**FINAL**  
**EXPLANATION OF SIGNIFICANT DIFFERENCES FOR**  
**GRANT HOUSING AREA AND 37-MM IMPACT AREA**

**FORMER FORT DEVENS ARMY INSTALLATION, DEVENS, MA**

**SEPTEMBER 2014**

Document Title: Draft Explanation of Significant Differences for Grant Housing Area and 37-MM Impact Area, Former Fort Devens Army Installation, Devens, MA

**Figure 1.2**  
**Site Location**  
**Grant Housing Area**  
**and 37-mm Impact Area/  
Oak and Maple Housing Areas**

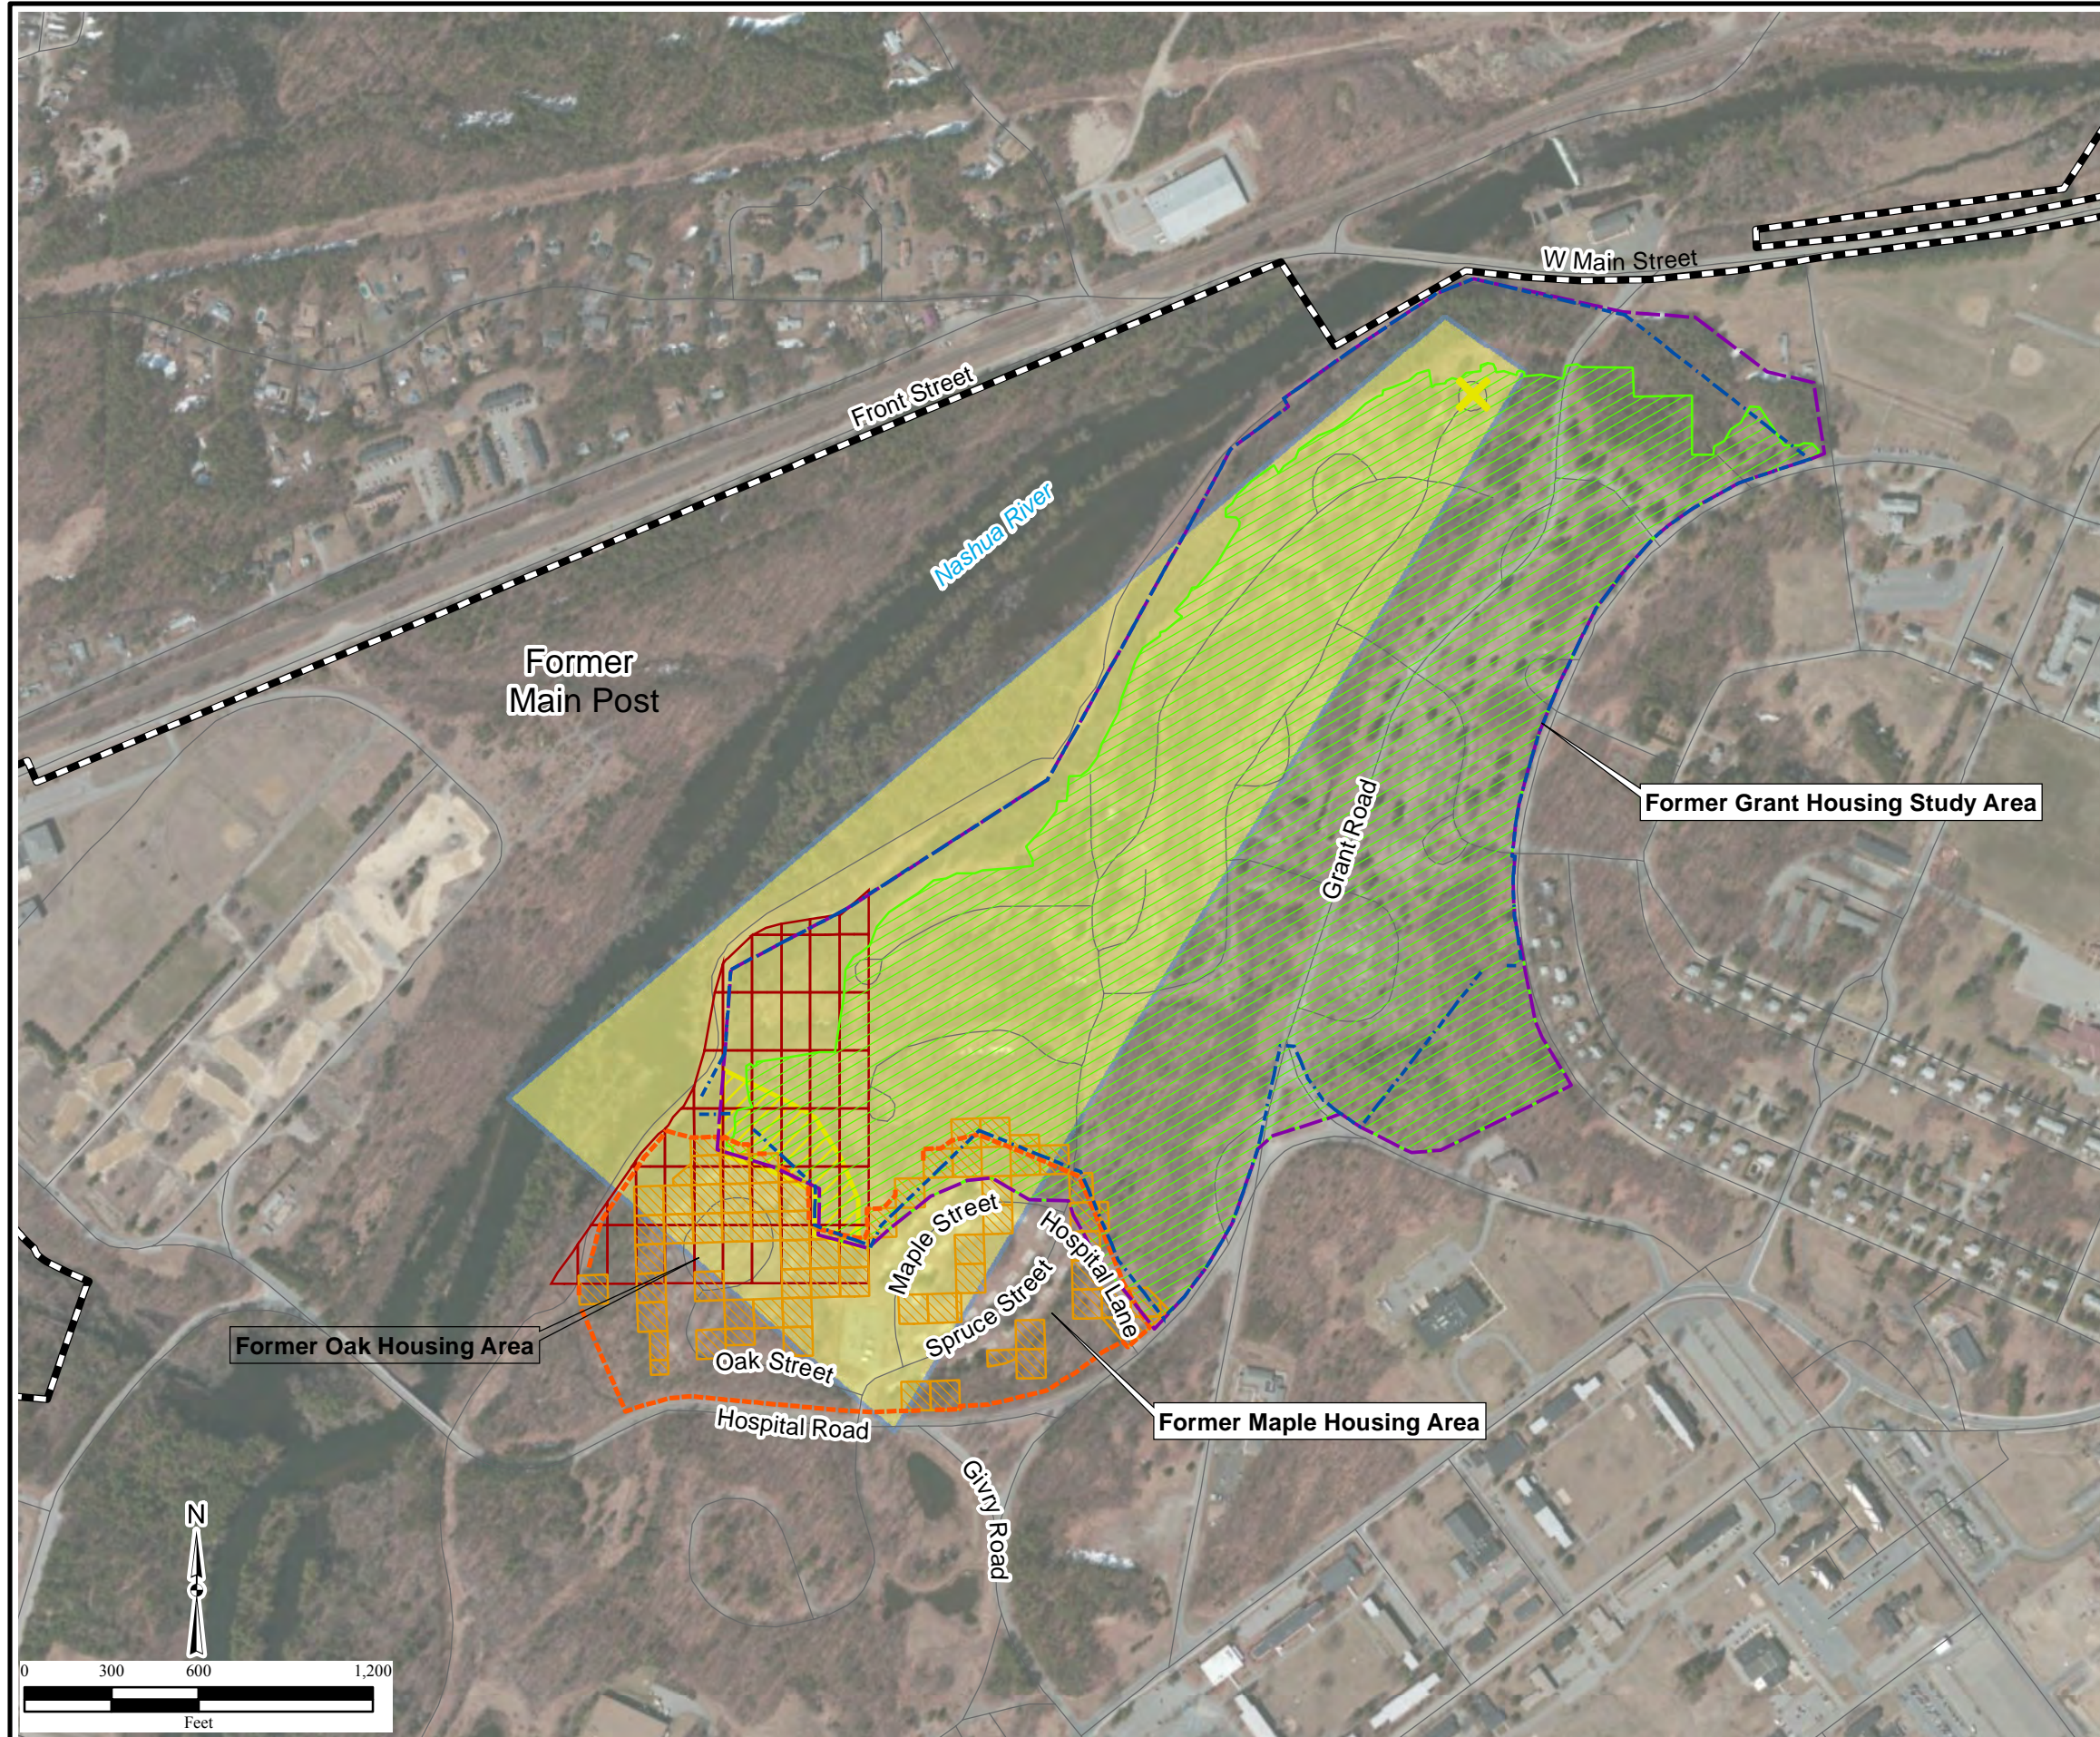
7. Figure 1.2: The referenced firing fan location (Section 1.1) should be identified.

- **Comment #10** - While EPA acknowledges the Army's presentation of "the lateral extent of the Grant and Oak/Maple HAs" in Figure 1.2, it remains convinced that the ESD should also contain a figure that includes the items requested in EPA's June 27, 2014 comments. Specifically, a new (or revised) figure, similar to Figure 3.1 in the 2012, MEC RI (for Oak and Maple), must be included that shows (1) the area (acreage) of the Grant/former 37 mm Impact Areas and the area (acreage) of the former Oak and Maple housing areas, and (2) demarcation of the lateral and vertical extent of UXO/MEC clearance in each area (as well as those areas where there is no or limited clearance). Members of the community (and other interested parties) should not have to locate and review "various historical reports" and other documents to discern the lateral and vertical extent of UXO/MEC clearance performed (or not performed) in each area. Figure 3.1, or another similar figure, could easily be amended to include the requested information.

DC	17.	Figure 1.2: The referenced firing fan location (Section 1.1) should be identified.	Figure 1		Figure 1.2 has been revised to include the firing fan location.
AM	18.	MassDEP legal staff requests to review the proposed deed restriction language.			The proposed deed restriction language will be provided as part of the LUCIP submittal.

FIGURES FROM RHE MEC RI REPORT WILL BE INCORPORATED INTO THE ESD TO ADDRESS THIS COMMENT.
